Property address or Location Seaway Drive
 Parcel ID #(s) 2402-504-0002-000-1
 Project description Construction of a 6,500 sf commercial building with drive-thru and 4,200 sf of storage units and associated site improvements

**Re: Major Amendment to PD, Development, & Design Review – Harbour Cay Phase II
Technical Review Project # 21-0700005, Response to TRC Comments**

On behalf of our client, please find the attached response to comments received at the April 15, 2021 TRC meeting for a project known as Harbour Cay Phase II. Each comment is identified below followed by a response in ***bold italics***.

Boundary Survey For: HARBOUR ISLE PLAZA

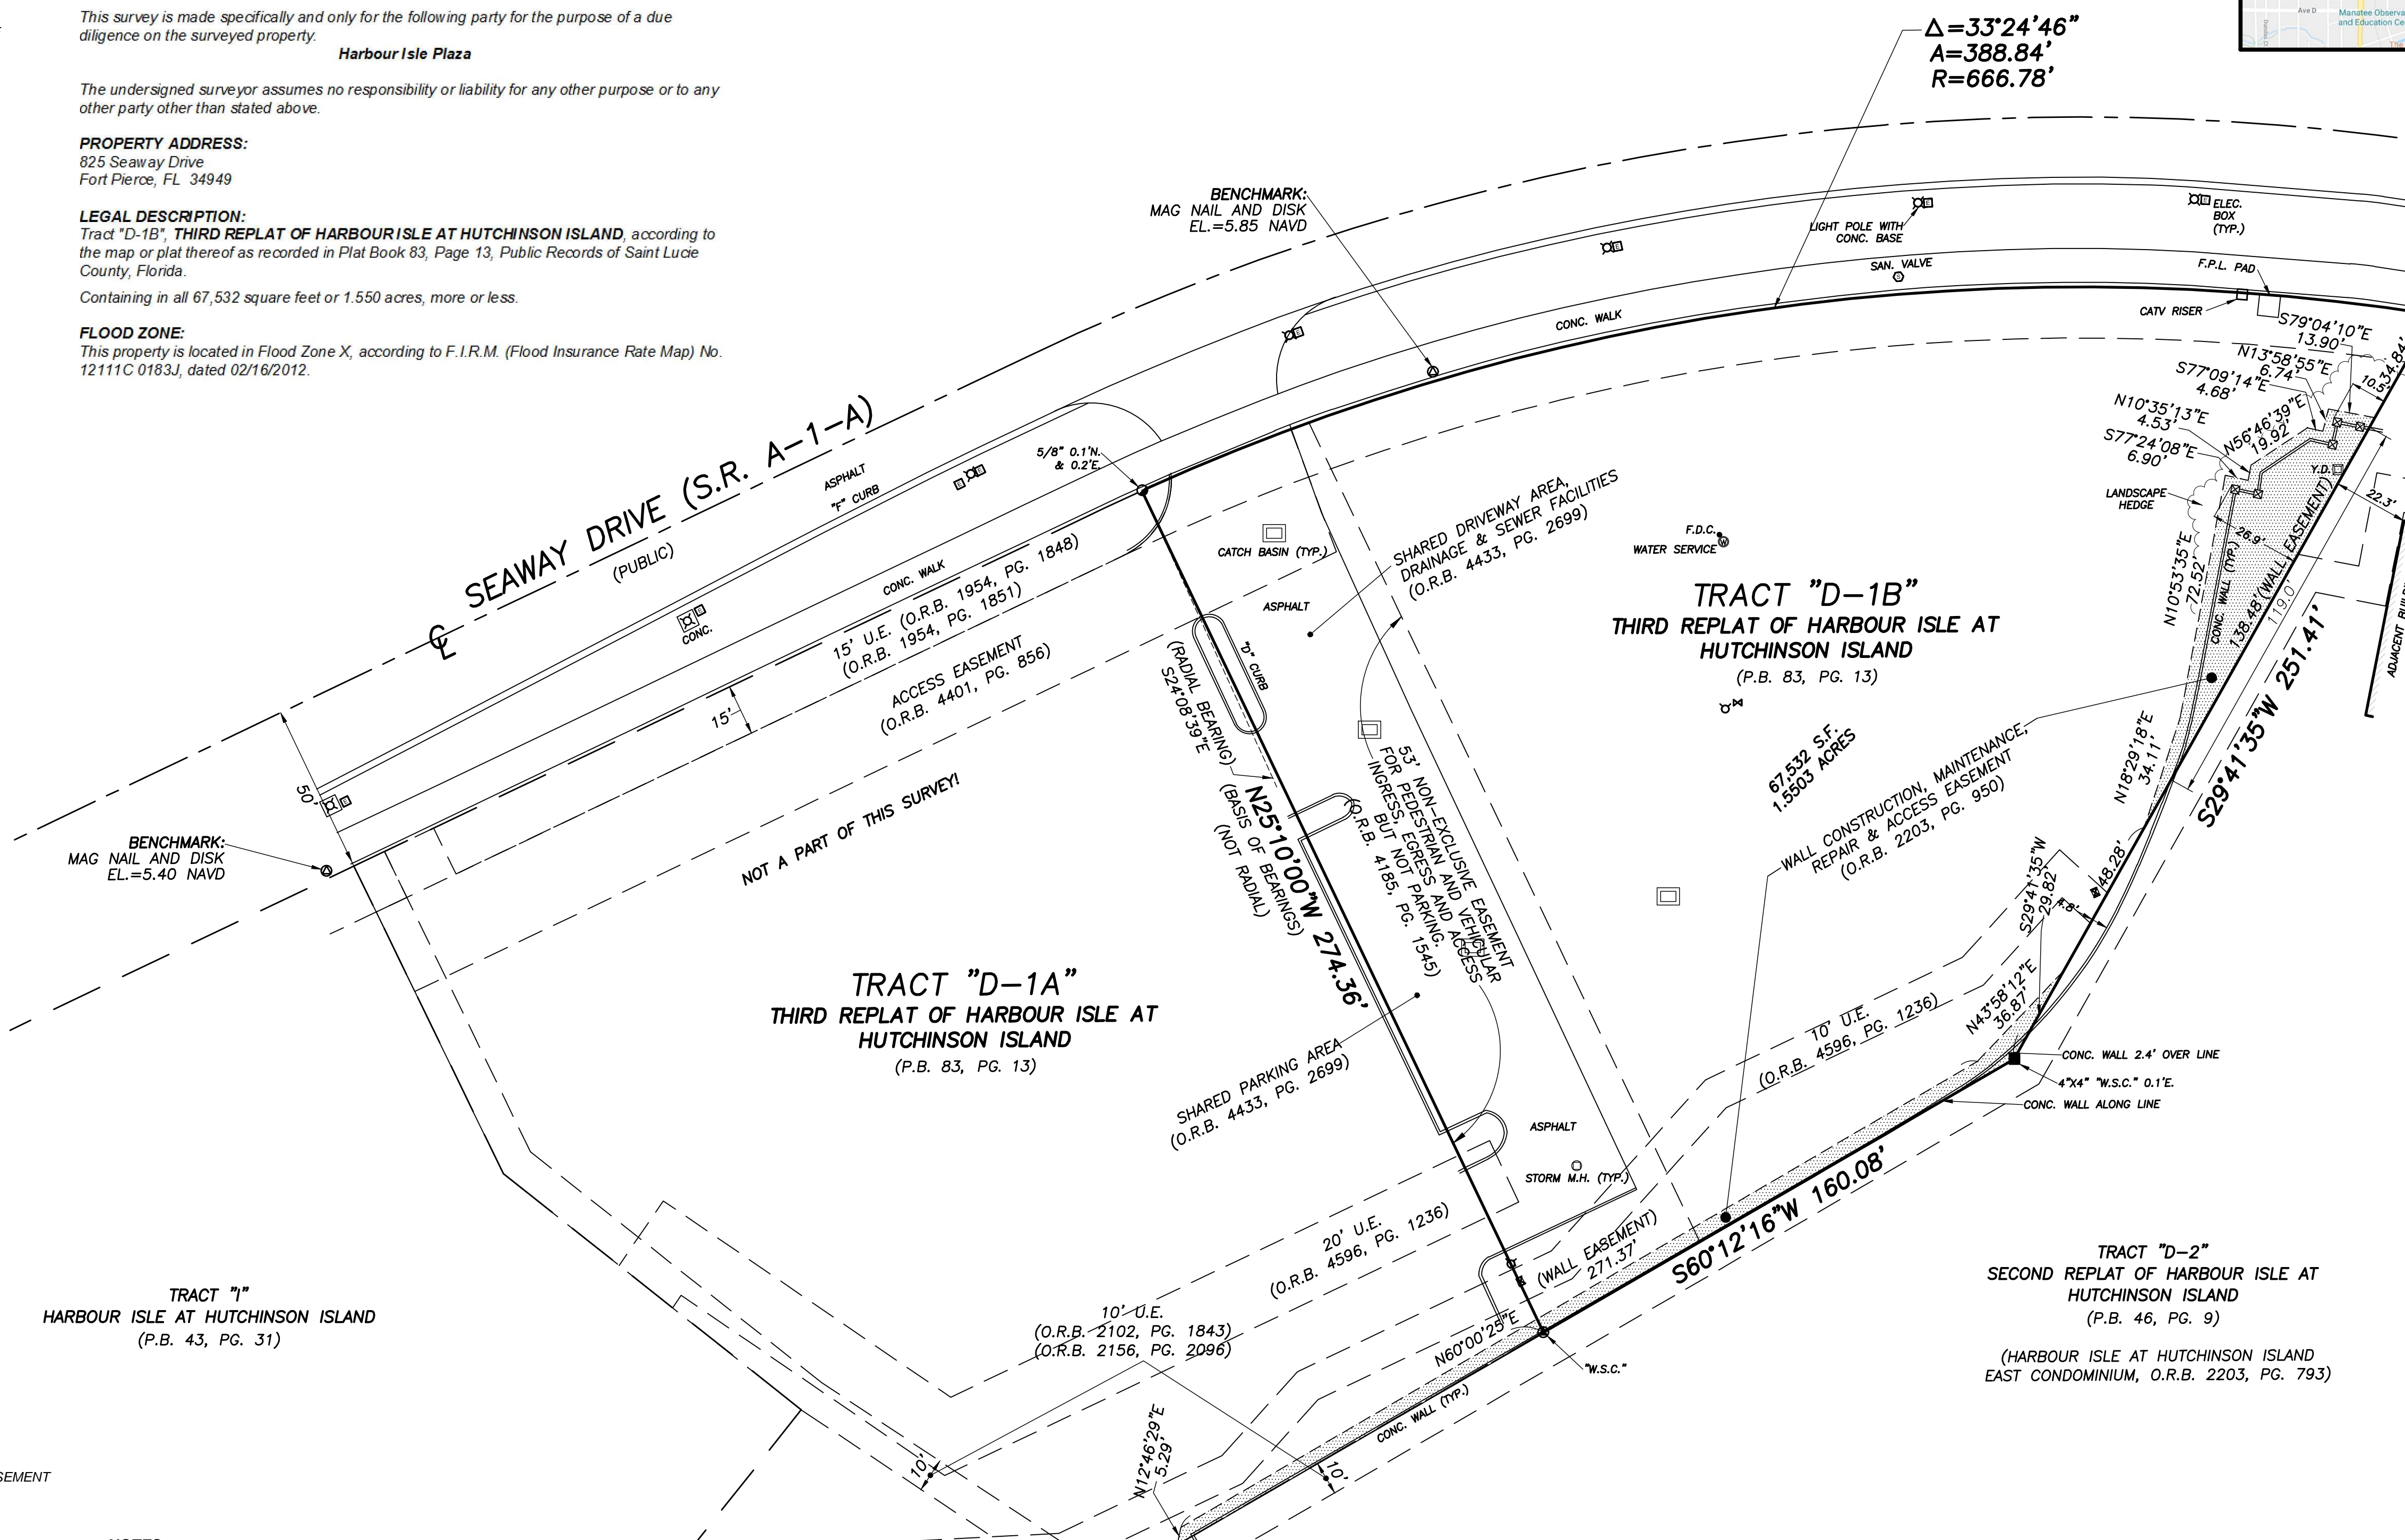
3. Provide a recent survey which clearly identifies the parcel's boundaries and the revised description of the 53' Ingress/Egress Easement to include the ORB and Page number.

RESPONSE: *Please see attached survey as requested.*

PROPOSED SIDE ELEVATION (EAST)
1/8" = 1'-0"

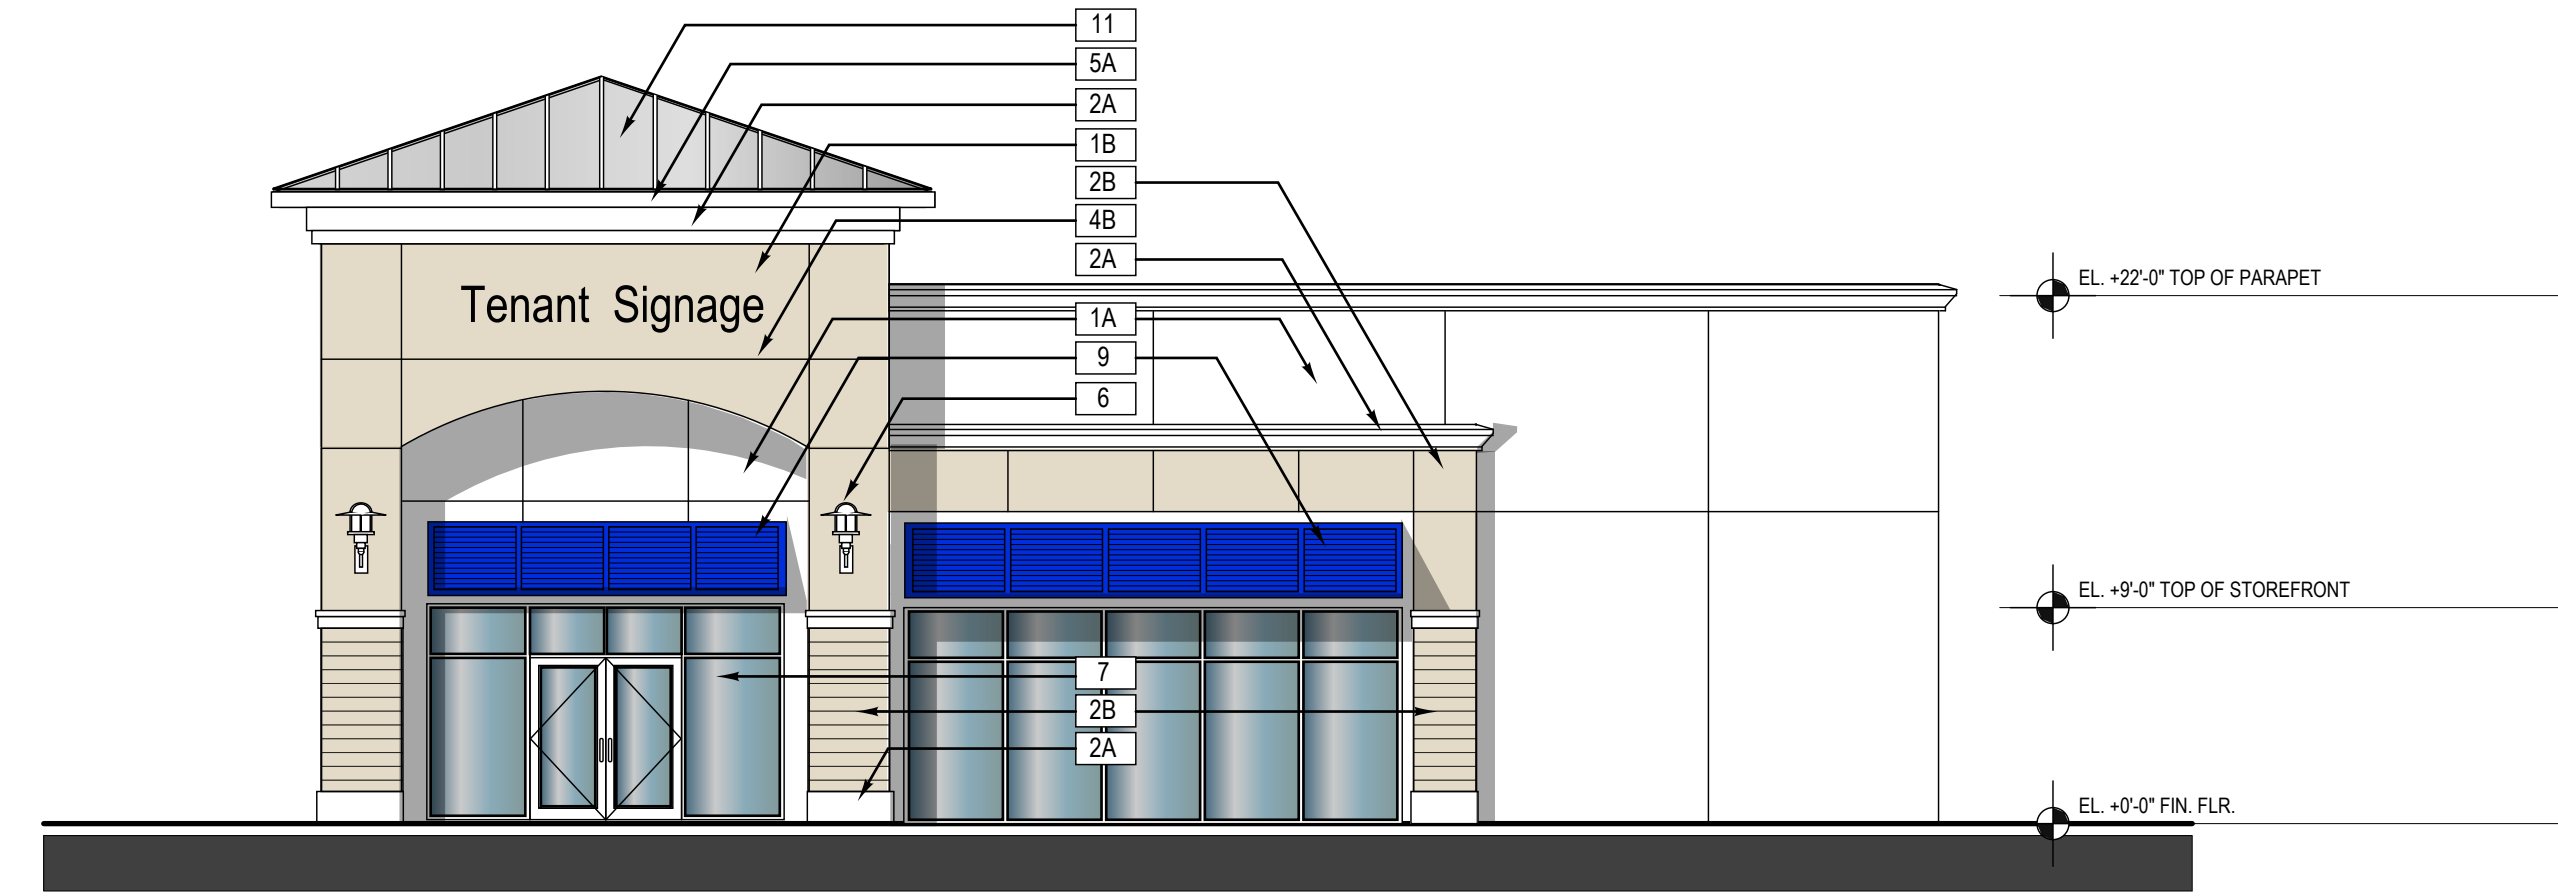
Overall, this is a nice design. However, consider adding a panoramic window to the east side of the building. The east elevation plan shows a planned brick wall at this time. The addition of a panoramic window will allow for "natural surveillance" by the users of the space (listed as future restaurant at this time) and would aide in deterring potential crime. The west side of the building does feature a window on that side.

RESPONSE: *We appreciate the recommendation but due to the interior design of the building (kitchen layout), a window on the eastern elevation cannot be accommodated.*

Figure 3a
Project Driveway Volumes
Harbour Cay

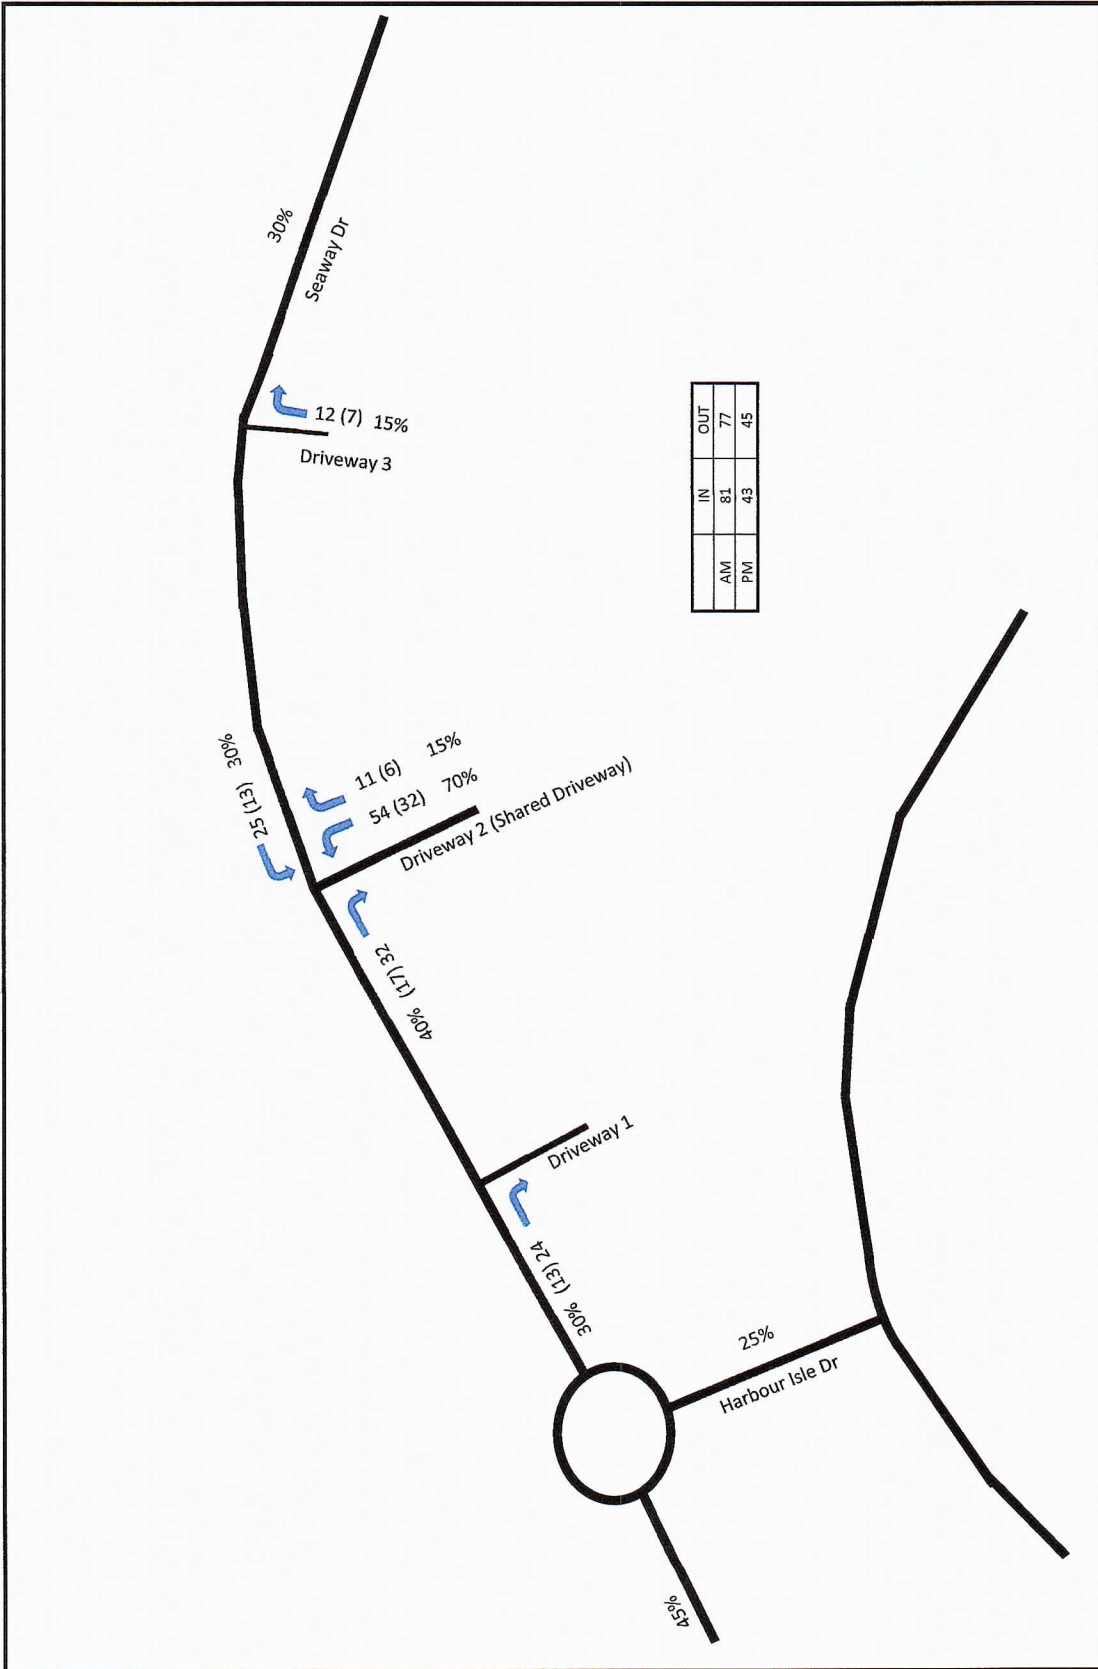
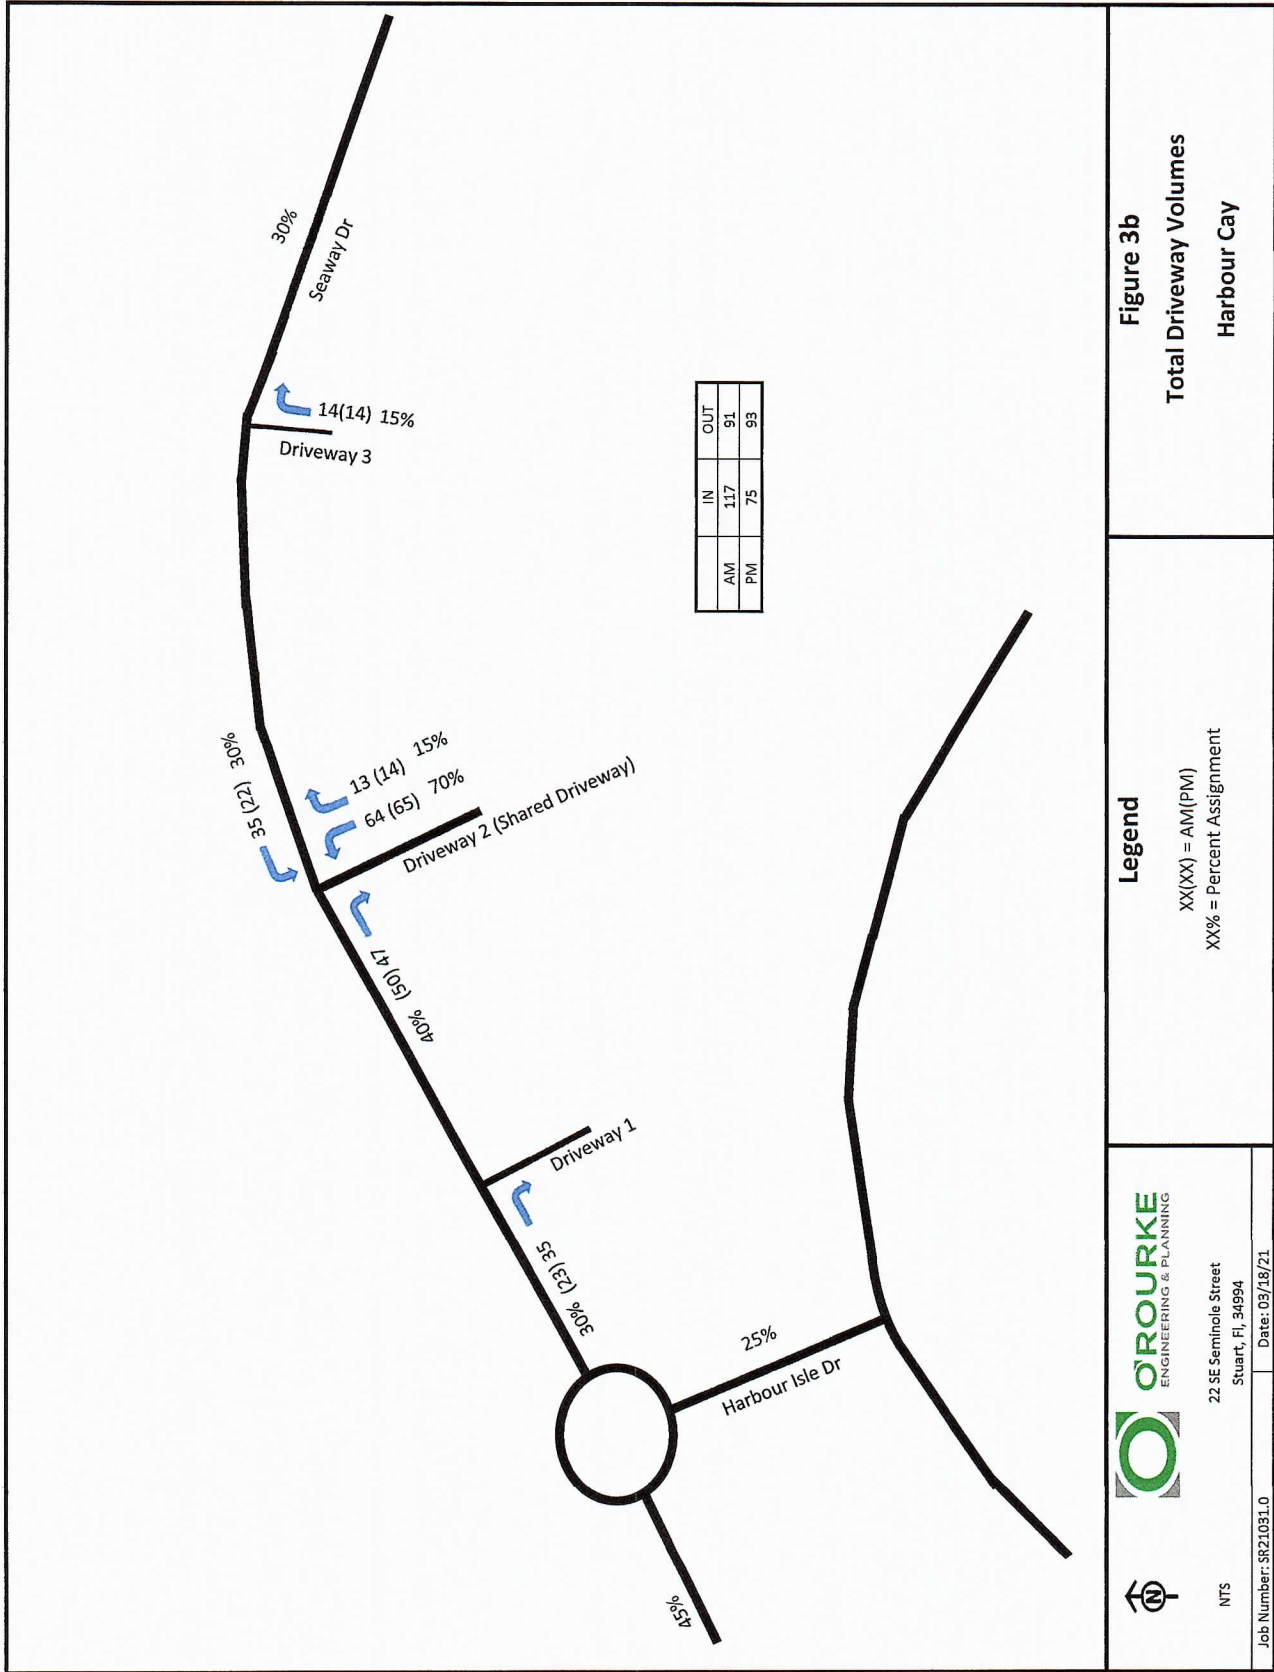
6. The trip distribution shown in the volume development worksheet does not match what is shown in Figure 3a/b. Please revise these worksheets and HCS analysis accordingly.

RESPONSE: *The volume development sheet has been revised to match Figure 3.*
